# Access Compliance Report

## Public Rights-of-Way

### (Curb Ramps)

Intersection ID: 10036644	Main Street: S_ALEXANDER_ST	Cross Street: N/A	Location: SW
ADA ID: E94689FD9876	Ramp Type: Perp	Initial Pass/Fail: Fail	Overall Compliance: No
Severity Score: 26.25			
Codes/Mitigation Info/Possible Solution		Field Measurements/Component Compliance

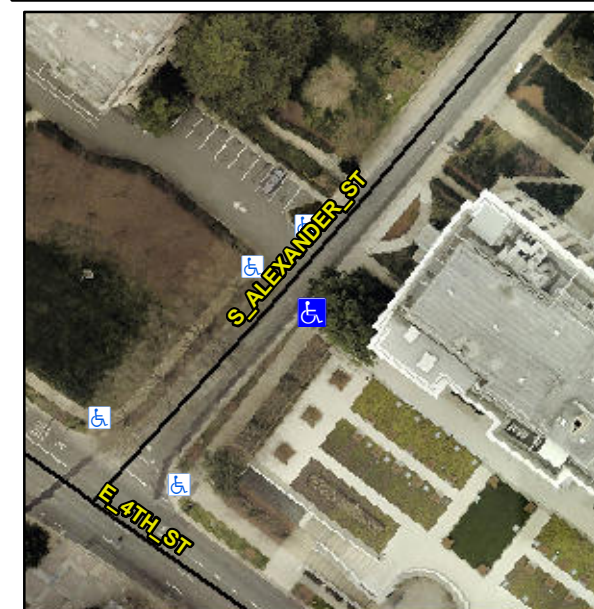
**R304.2.2, R304.5.3**

Compliance	Description	Data	Compliance	Description	Data
N/A	Ramp Length (in)	32.0	No	Ramp Slope (%)	19.3
Yes	Ramp Width (in)	122.0	No	Ramp XSlope (%)	2.6
N/A	Flare Type LT	N/A	N/A	Flare Type RT	N/A
N/A	Flare Slope LT (%)	N/A	N/A	Flare Slope RT (%)	N/A
N/A	Flare Traversable LT?	N/A	N/A	Flare Traversable RT?	N/A
N/A	Landing Length (in)	N/A	N/A	DWS Provided?	N/A
N/A	Landing Width (in)	N/A	N/A	DWS Contrast?	N/A
N/A	Landing Slope (%)	N/A	N/A	DWS Length (in)	N/A
N/A	Landing X Slope (%)	N/A	N/A	DWS Full Width?	N/A
N/A	Landing Curb? (Y/N)	N/A	N/A	DWS Offset (in)	N/A
N/A	Shared Landing?	N/A			
N/A	Gutter Ponding?	N/A	N/A	Gutter Slope (%)	N/A
N/A	Gutter Lip Ht (in)	N/A	N/A	Gutter X Slope (%)	N/A
N/A	Painted X Walk1?	No	N/A	Painted X Walk2?	N/A
	X Walk 1 Direction	To N		X Walk 2 Direction	N/A
N/A	X Walk 1 Width (in)	N/A	N/A	X Walk 2 Width (in)	N/A
	X Walk 1 Slope (%)	1.2		X Walk 2 Slope (%)	N/A
	X Walk 1 X Slope (%)	2.5		X Walk 2 X Slope (%)	N/A

**Remove & Replace Entire Ramp.**
